APPLICATION TO AMEND A PLANNED DEVELOPMENT OR PUD and/or

Project Name: Avida (f/k/a Oasis Cove)

☒ Amendment to a PD or PUD to allow: Reconfiguration of master concept plan and related revisions

Administrative Amendment to Planned Development Narrative of Request

INDIGENOUS CREATION REVISION EXHIBIT

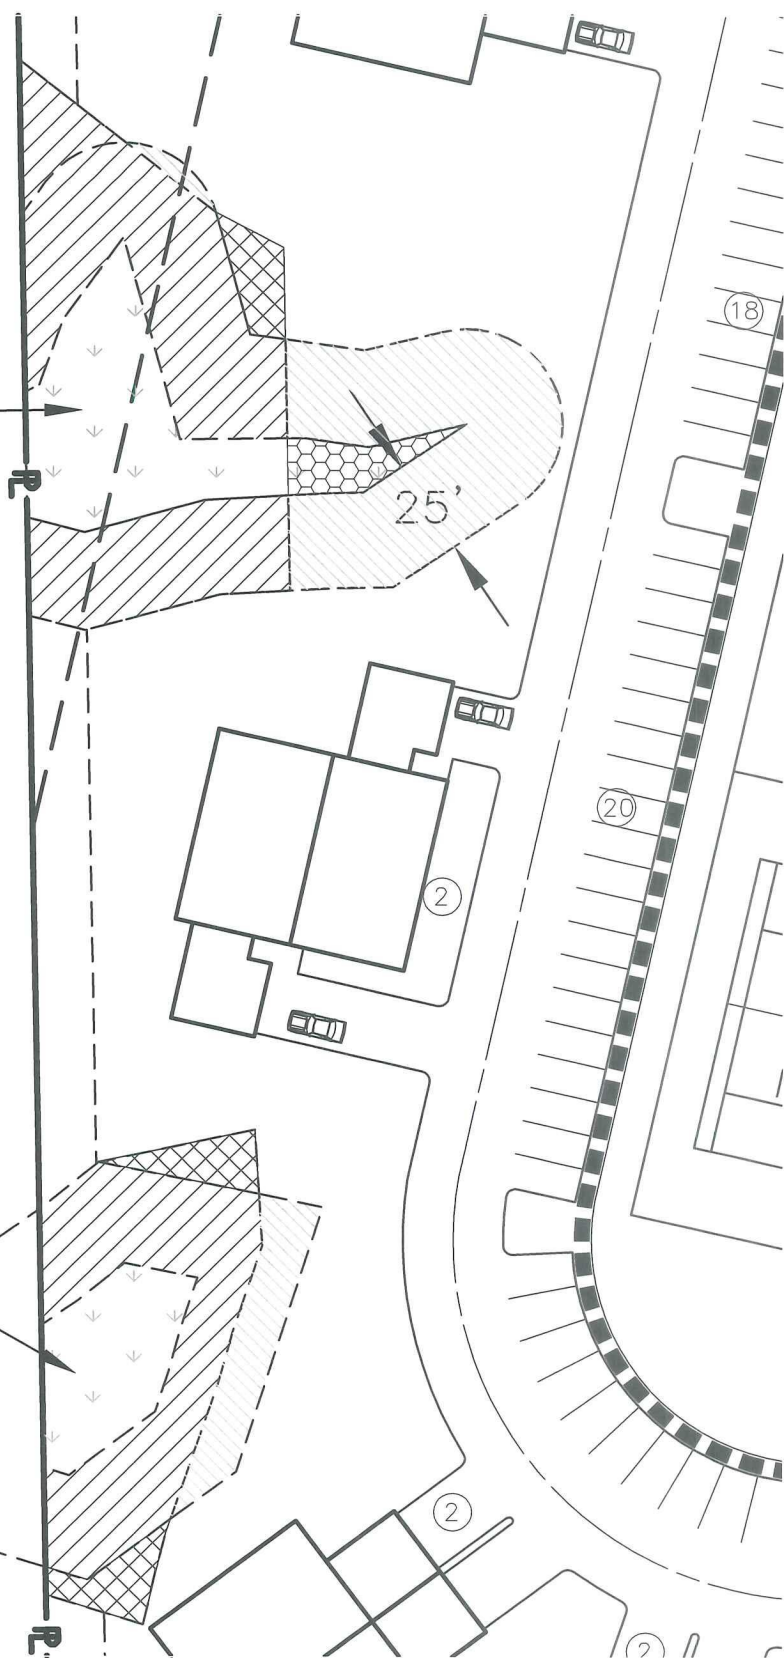
PREVIOUS INDIGENOUS
CREATION AREA
TO BE REMOVED **0.02 AC.**

PROPOSED REPLACEMENT
INDIGENOUS CREATION
AREA ADDED **0.10 AC.**

PREVIOUS APPROVED
INDIGENOUS AREA TO BE
IMPACTED NOW PROPOSED TO
BE PRESERVED **0.01 AC.**

NET INCREASE OF **0.08 AC.**
INDIGENOUS CREATION

NET DECREASE OF INDIGENOUS
AREA TO BE IMPACTED **0.01 AC.**

MASTER CONCEPT PLAN AVIDA LEE COUNTY, FLORIDA							
DATE	PROJECT	DRAWING	DESIGN	DRAWN	CHECKED	SCALE	SHEET
1/21/2016	1620	MCP	SEH	JS	SEH	1" = 200'	1 1

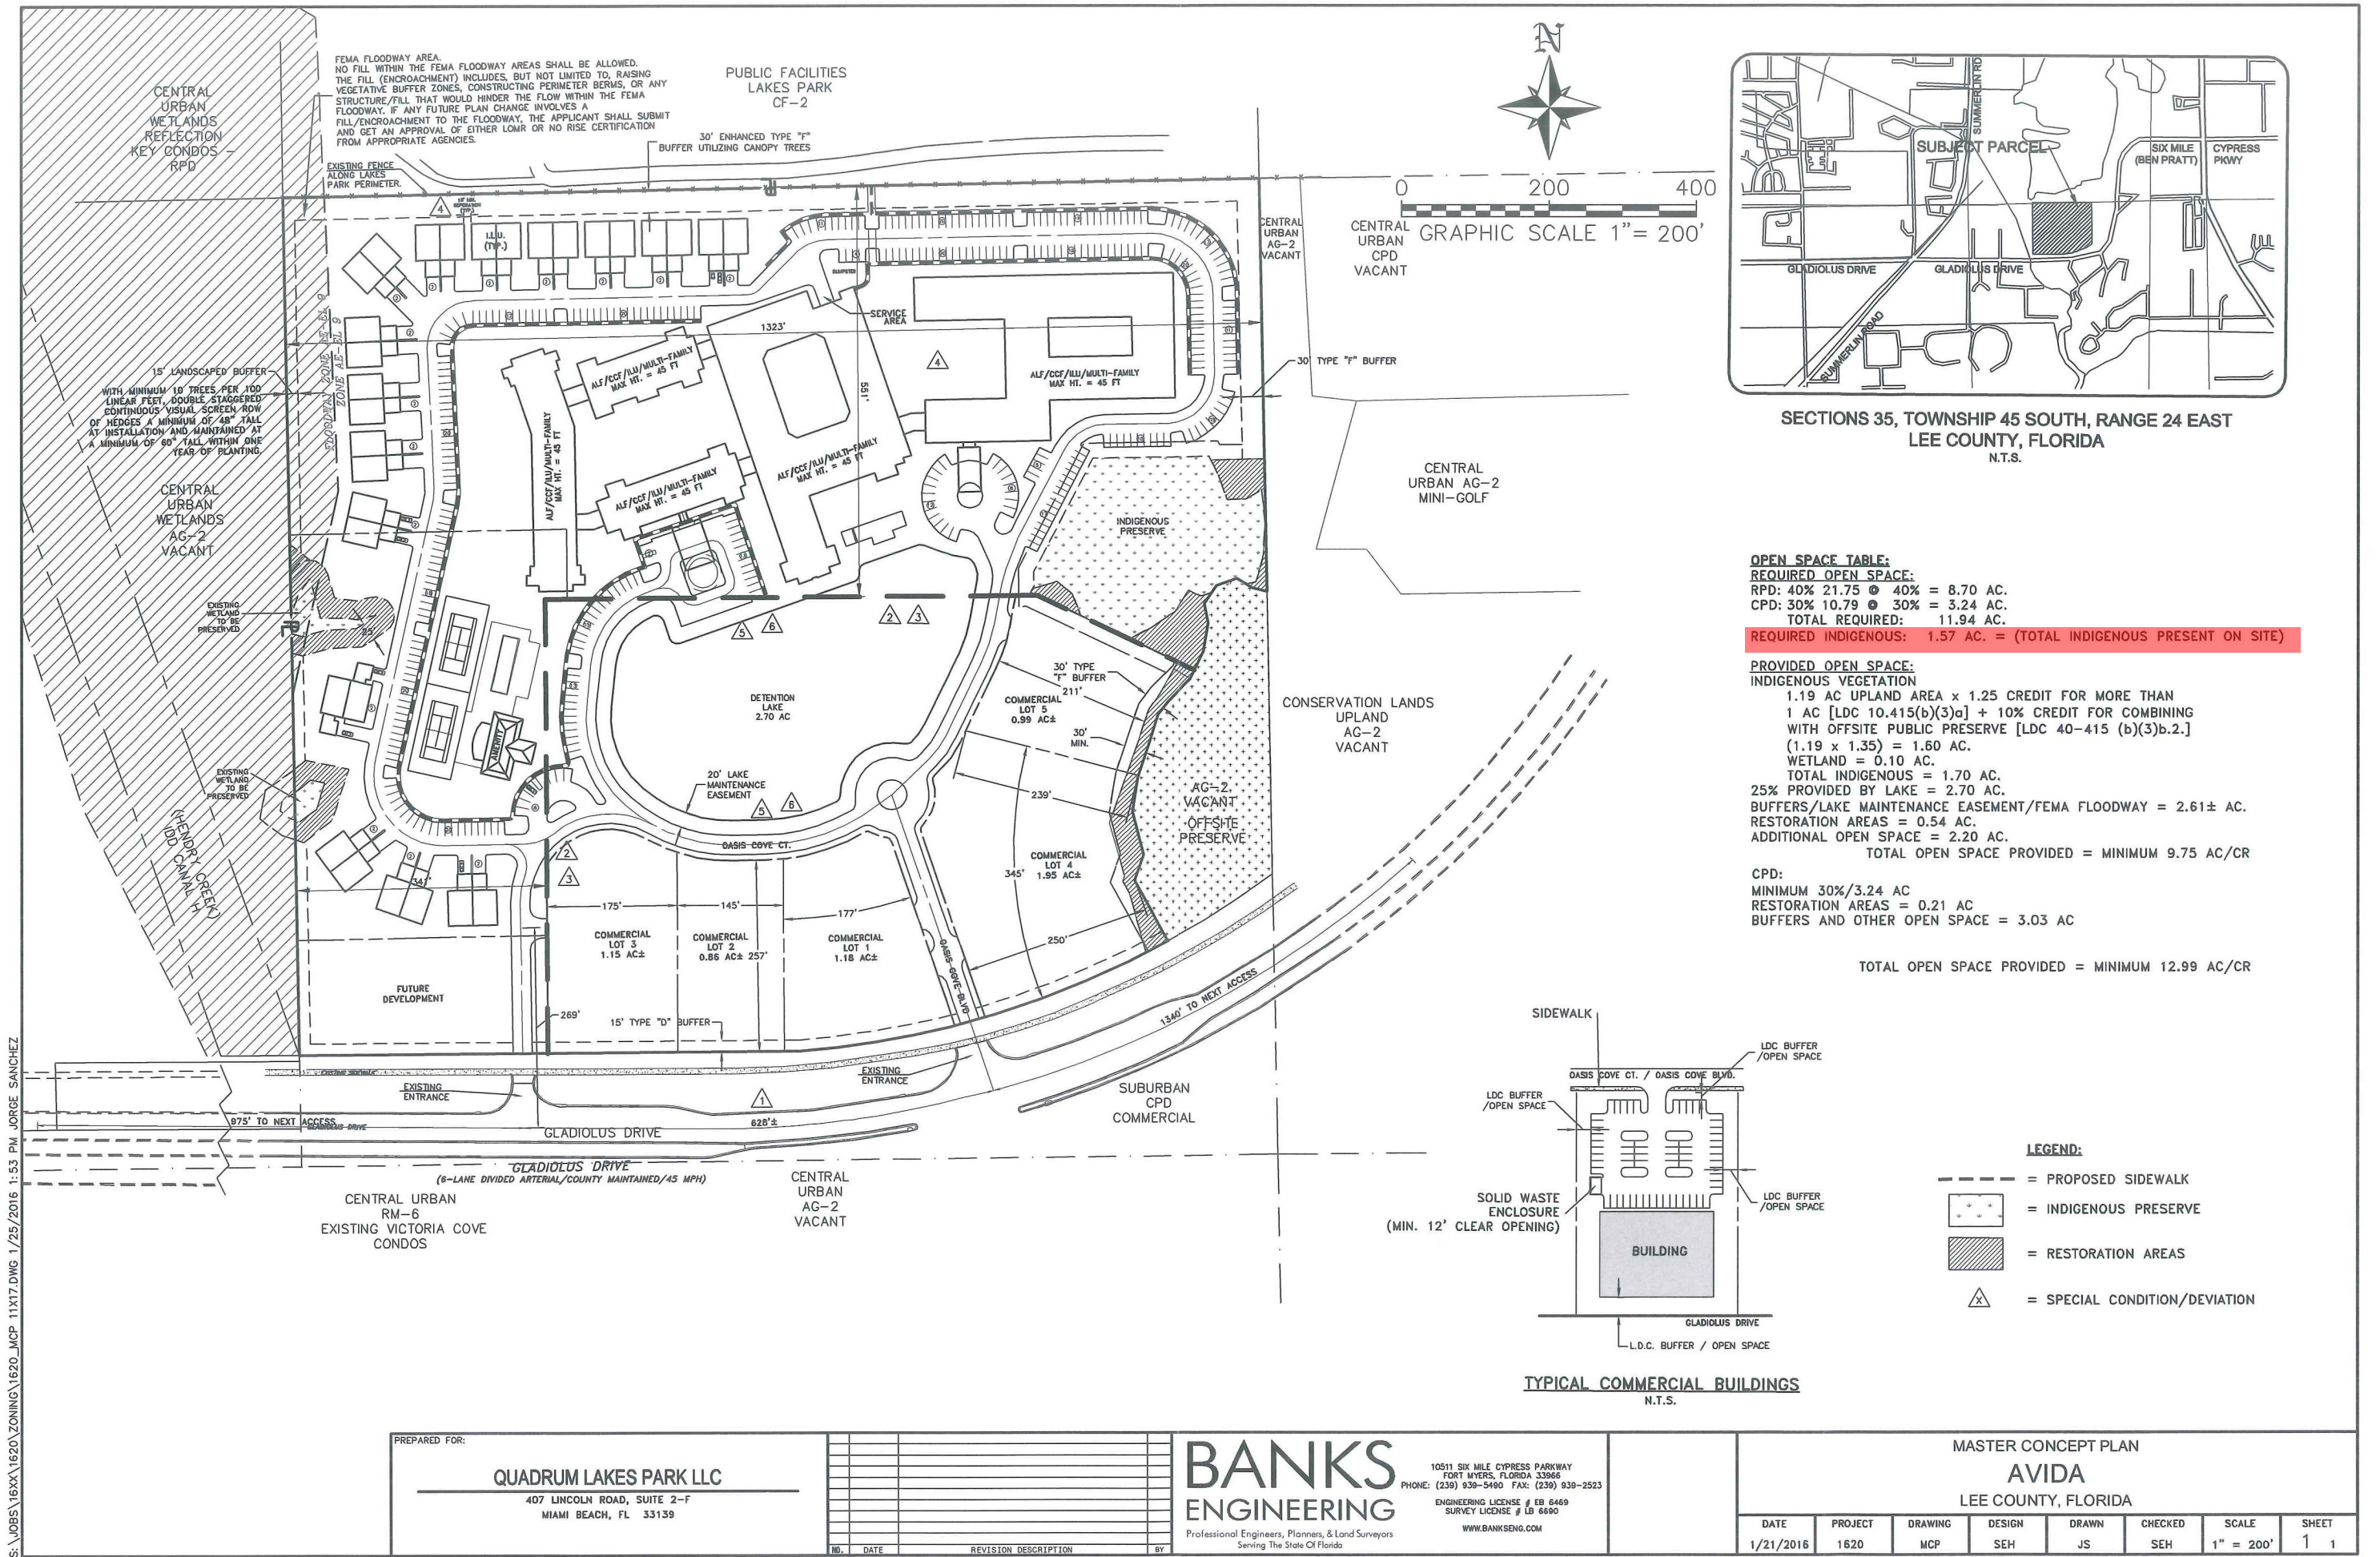
The applicant purchased the property on July 29, 2015 and has revised the proposed site layout—The master concept plan has been revised to demonstrate relocation of the proposed lake, reconfiguration of the proposed buildings and accessways within the RPD portion of the site, and reconfiguration of the lots and accessways within the CPD portion of the site. The development of the RPD and CPD will remain under unified control. The development will provide land leases in lieu of selling off parcels and will maintain unified

ownership. The master concept plan demonstrates the required parking for the RPD area located within the RPD. The master concept plan demonstrates overflow parking in the CPD area that will be accessible to either the RPD or the CPD, given the unified nature of the development. The CPD has been revised from 7 lots to 5 lots. There are no proposed changes to external access points or perimeter buffers.

- Setbacks: Water body: 20 feet or 0 feet where bulkheads or other hardened shoreline structures are provided and
- Minimum building separation: 10 feet for single-story buildings and 20 feet all other buildings.
